Federal Aviation Administration

Memorandum

Subject: Teardown investigation of an Ameri-King AK-450-[] series Emergency Locator
Transmitter (ELT) sent from the National Transportation Safety Board (NTSB).
(Refer to NTSB ERA17FA231)

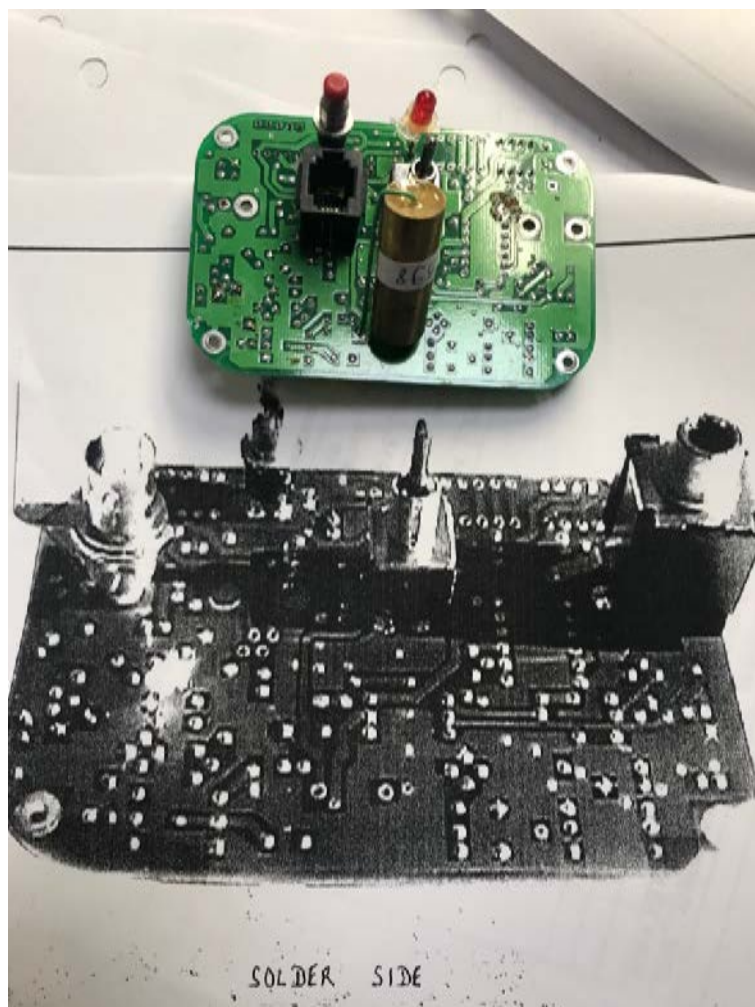
It was noted that the circuit board did not match the photo with the approved drawings indicating it was not the approved design.

5. On Page 12 it indicates that the circuit board did not match the photo with the approved drawings. Was it an unapproved part?
[The circuit board did not match the approved drawing so as it was observed it was not approved.](#)

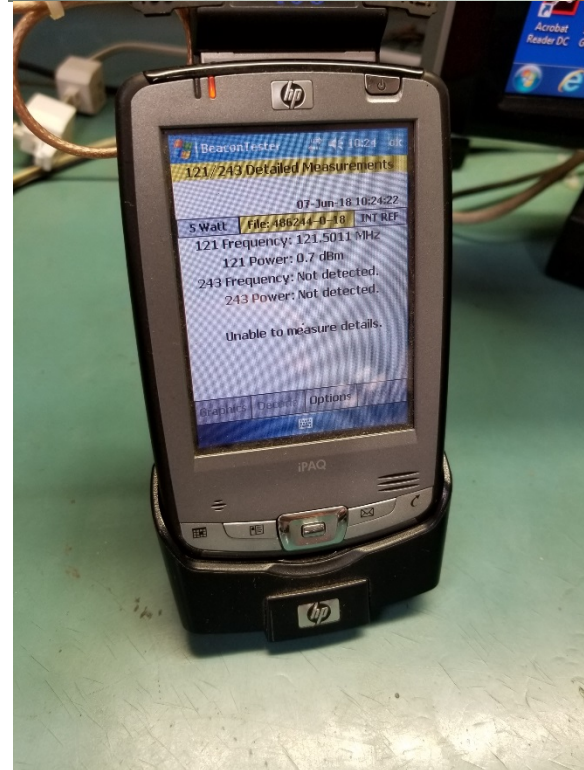
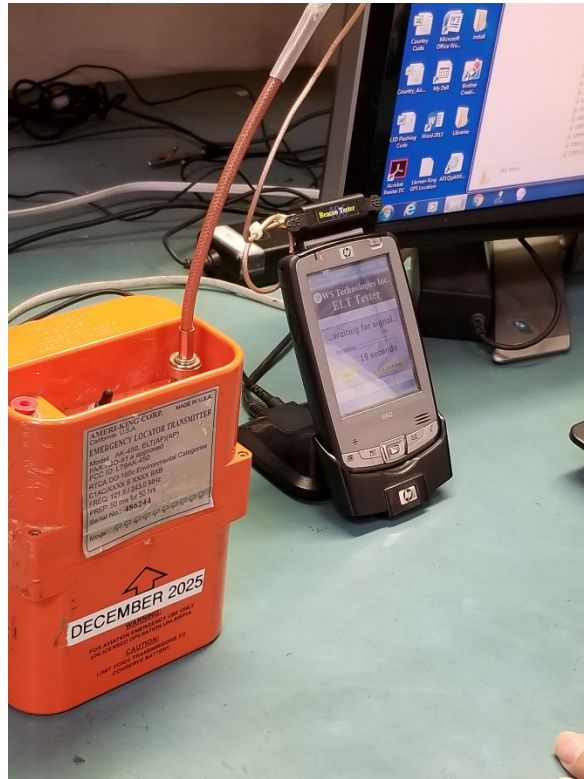
6. On Page 13 I need to have the notes clarify where the antenna was connected. Was it to the BNC fitting of the ELT?
[The antenna was connected to the BNC antenna connection on the ELT](#)

7. Page 13 references a re-soldering of the antenna connector the day before. I did not see that in any of the previous pages of the Memorandum and need that added in the appropriate location of the Memorandum
[Updated page 2 to match page 13.](#)
